MONITORING YEAR 3 ANNUAL REPORT

LONE HICKORY MITIGATION SITE

RE: Lone Hickory Mitigation Site – Monitoring Year 3 Report Draft
Yadkin River Basin – CU# 03040101 – Yadkin County
DMS Project ID No. 97135
Contract # 6897

Wildlands Engineering, Inc. (Wildlands) has reviewed the Division of Mitigation Services' (DMS) comments from the Draft Monitoring Year (MY) 3 report for the Lone Hickory Mitigation Site. DMS' comments are noted below in **bold**. Wildlands' responses to those comments are noted in *italics*.

Wetland Re-est

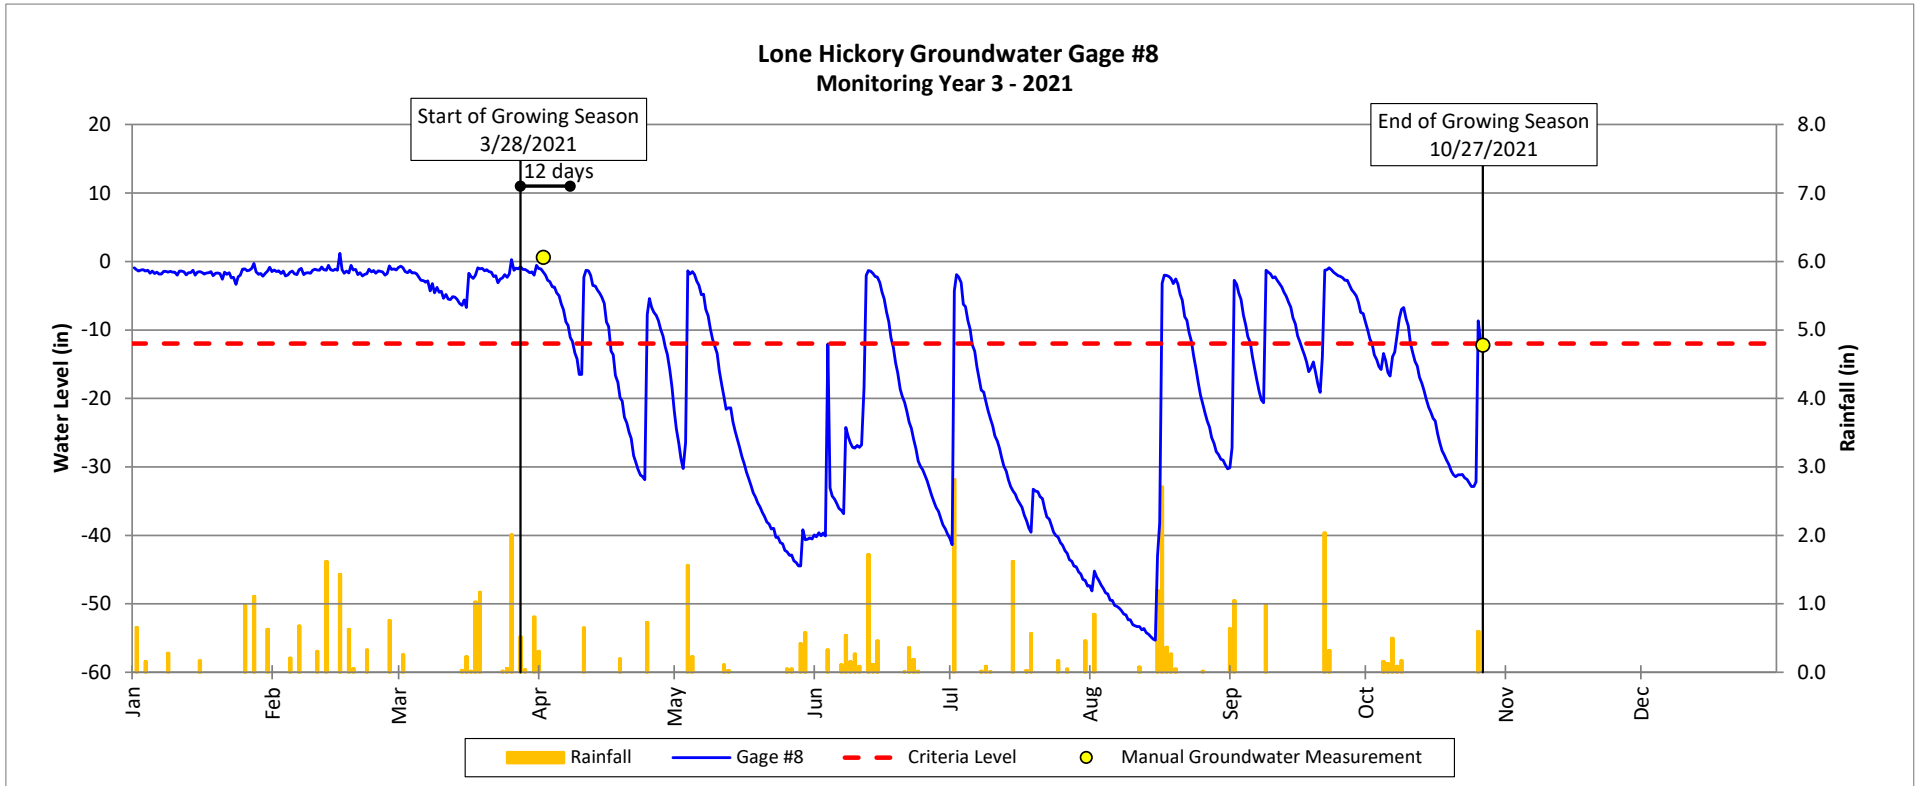
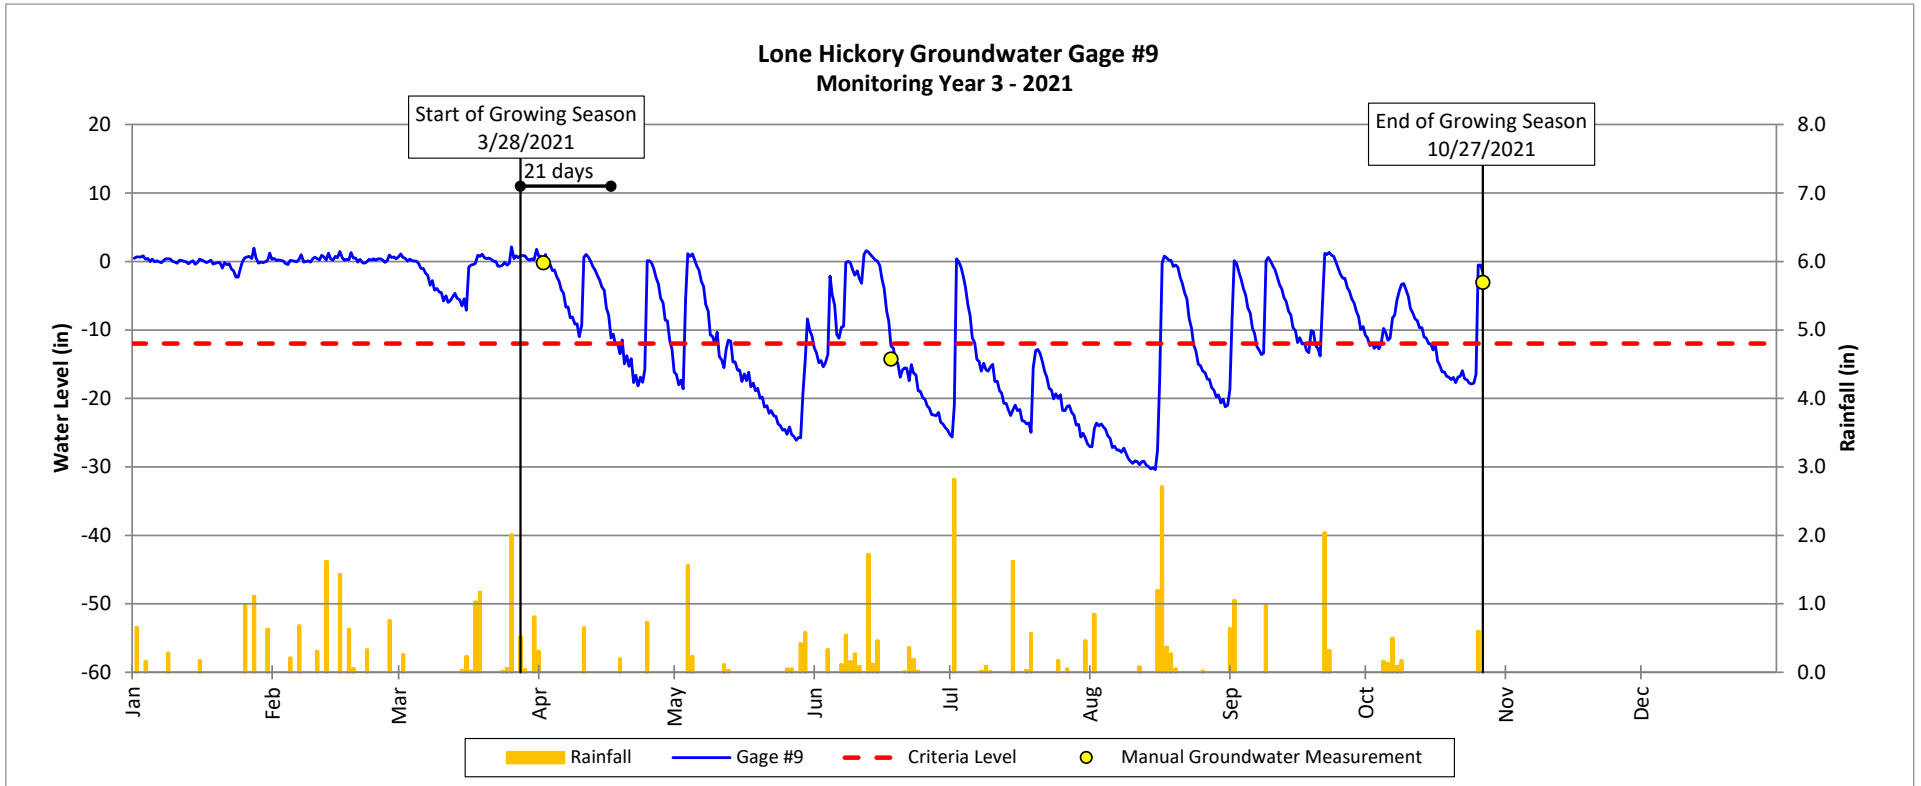
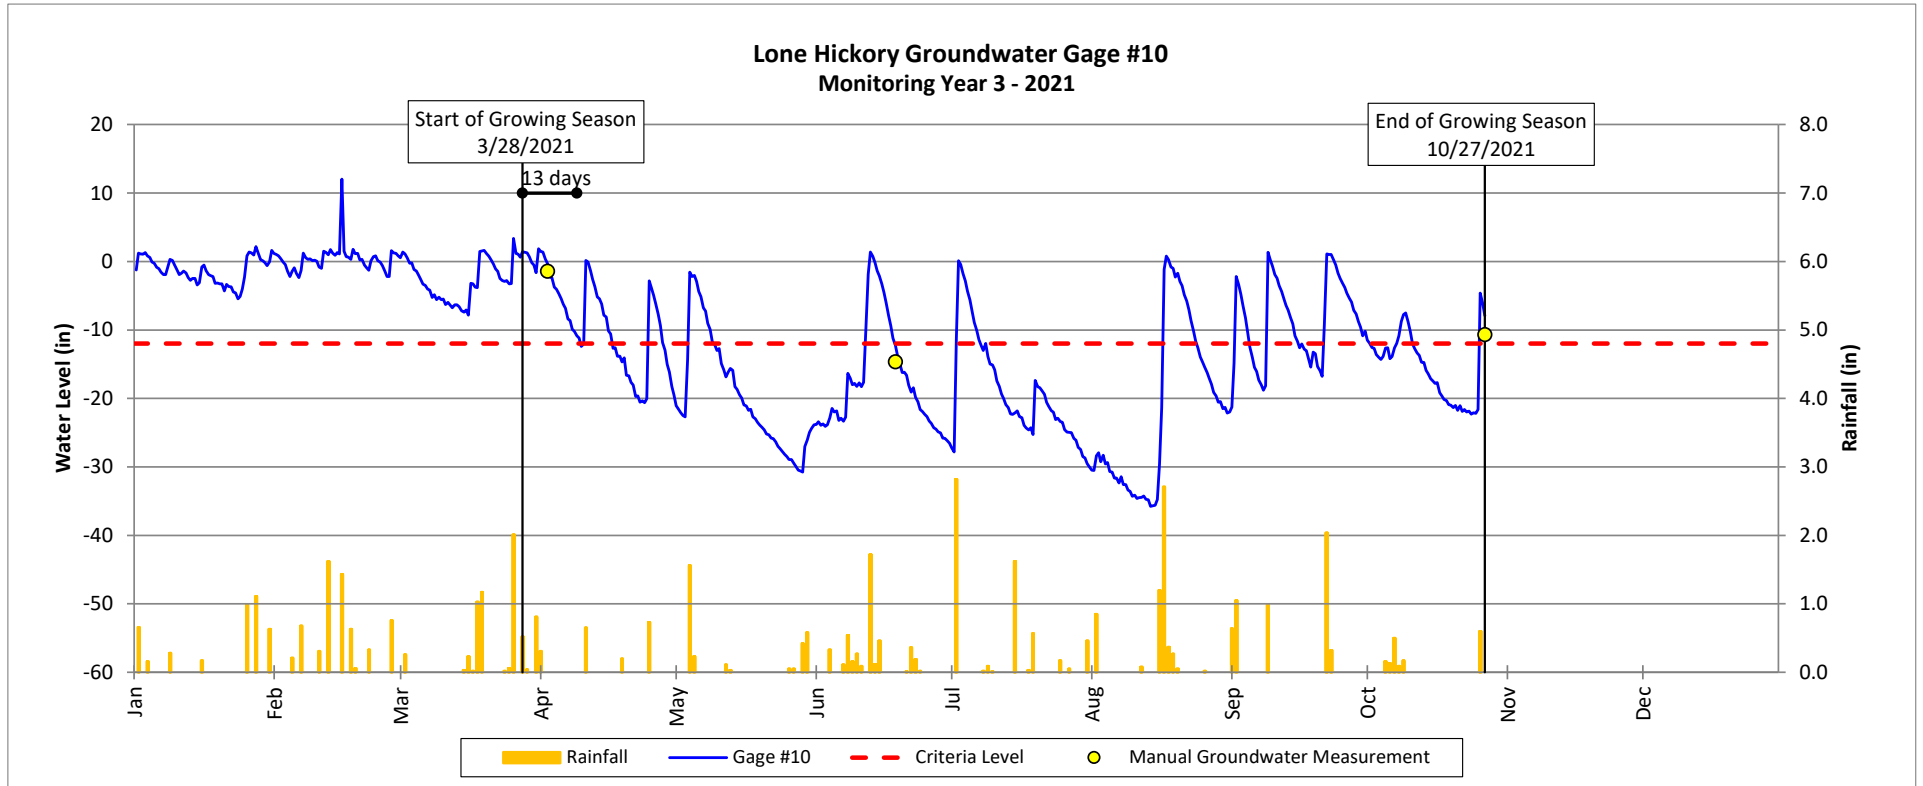
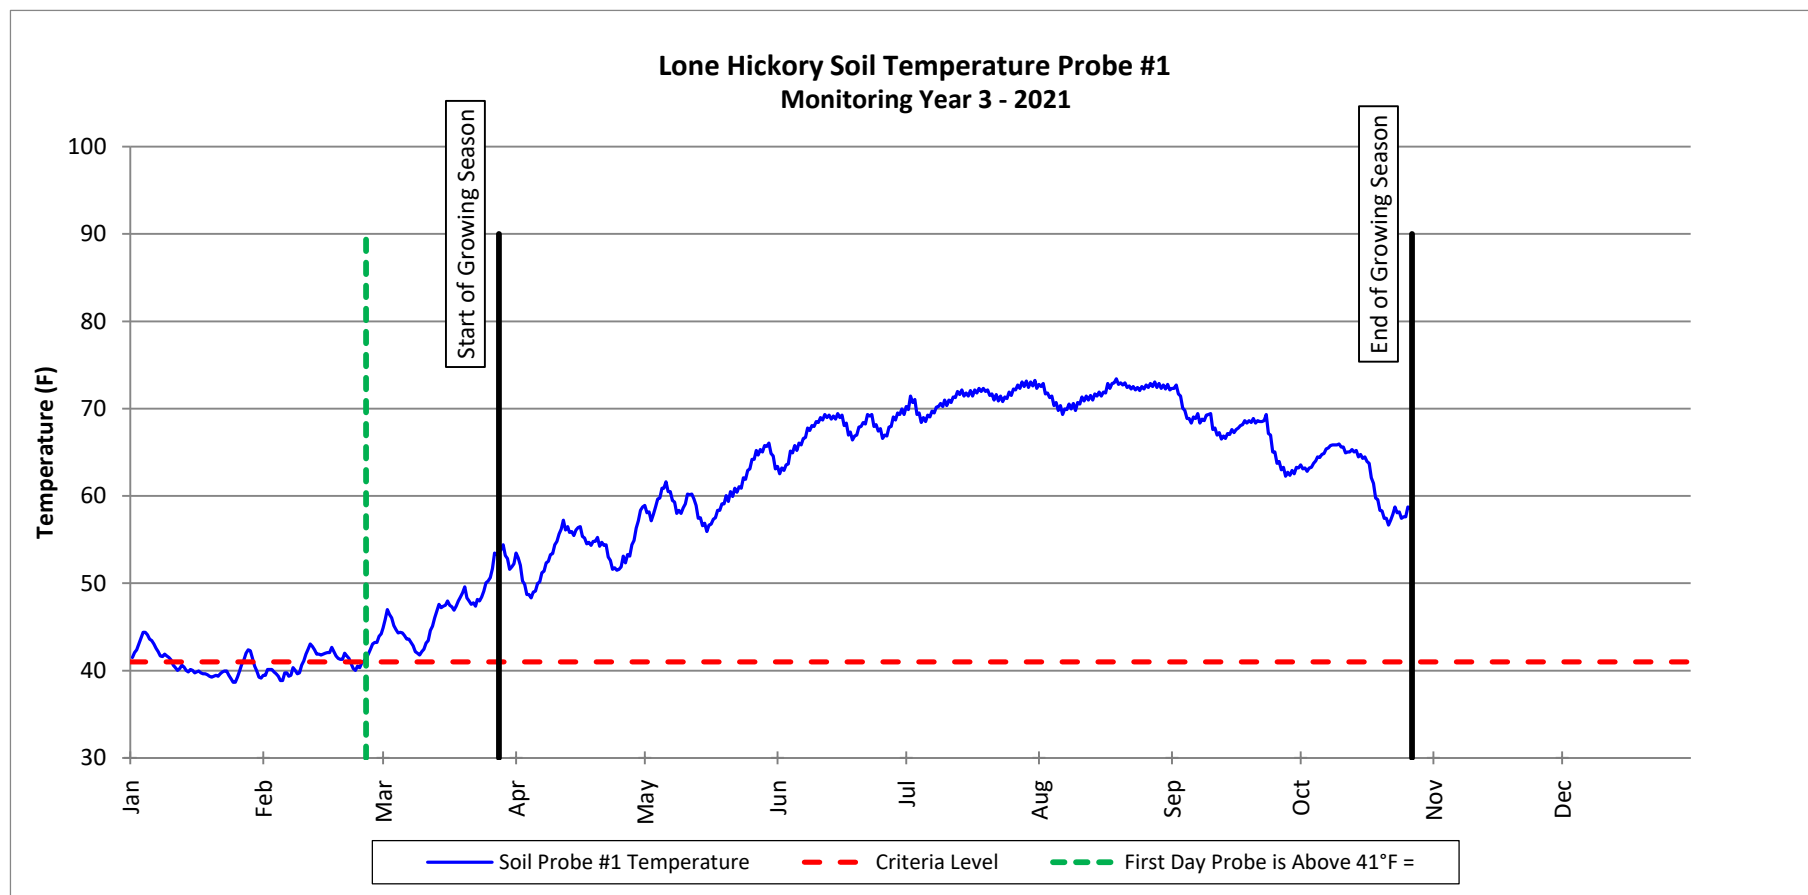
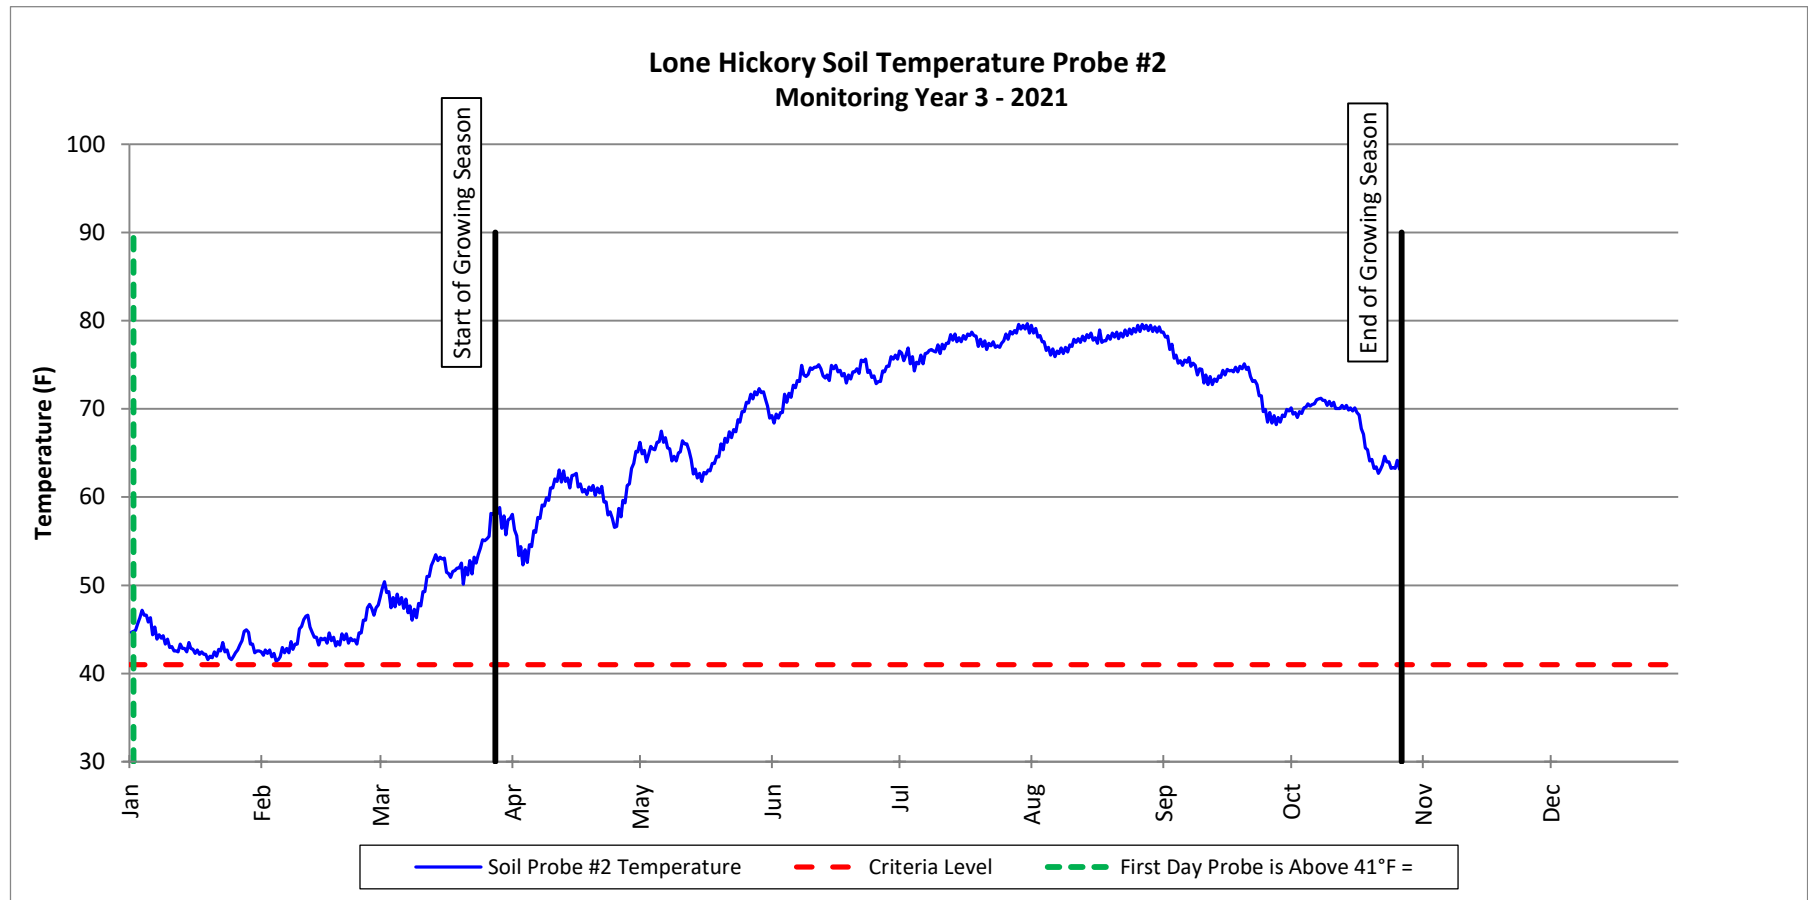
DMS' comment: General: Per the 12/8/2017 IRT approved mitigation plan; "The final performance standard for wetland hydrology will be a free groundwater surface within 12 inches of the ground surface for 19 consecutive days (9.2 percent) of the defined growing season for Yadkin County (April 4 through October 27) under typical precipitation conditions." The IRT approved mitigation plan does not mention the use of bud burst data or soil temperature data to amend the established growing season.

Additionally, the IRT has indicated that if mitigation providers intend to utilize bud burst and soil temperature data to extend the start of the growing season then they must also utilize this data to amend the end date of the growing season. In some cases, the IRT has allowed the use of the most current WETS (USDA 2021) data to determine the growing season start and end dates; however, the IRT has indicated that they do not want growing seasons to vary in each monitoring year.

If Wildlands intends to amend the growing season dates established in the IRT approved mitigation plan, documentation and approval will be required from the IRT. The IRT will likely require a mitigation plan addendum to amend the established growing season dates.

While it is acceptable to provide complimentary/ comparison data in the report appendices, the text, tables, groundwater gage plots and CCPV maps should clearly report monitoring results based on the established success criteria. Please update the MY3 (2021) report and digital support files based on the success criteria established in the 2017 IRT approved mitigation plan.

Wildlands' response: At the present time, Wildlands does not intend to amend the established growing season dates from the approved Mitigation Plan. Text in the executive summary, Section 1.2.4, and Section 1.3 have been updated and the monitoring results are based on the growing season dates established in the approved Mitigation Plan. CCPV maps and Appendix 5 have been updated, as well. An analysis of the groundwater gage data with an extended growing season, beginning one week earlier on

March 28, 2021, is included in Section 1.2.4 for comparison purposes only. Supplemental groundwater gage and soil temperature plots have been added to Appendix 6.
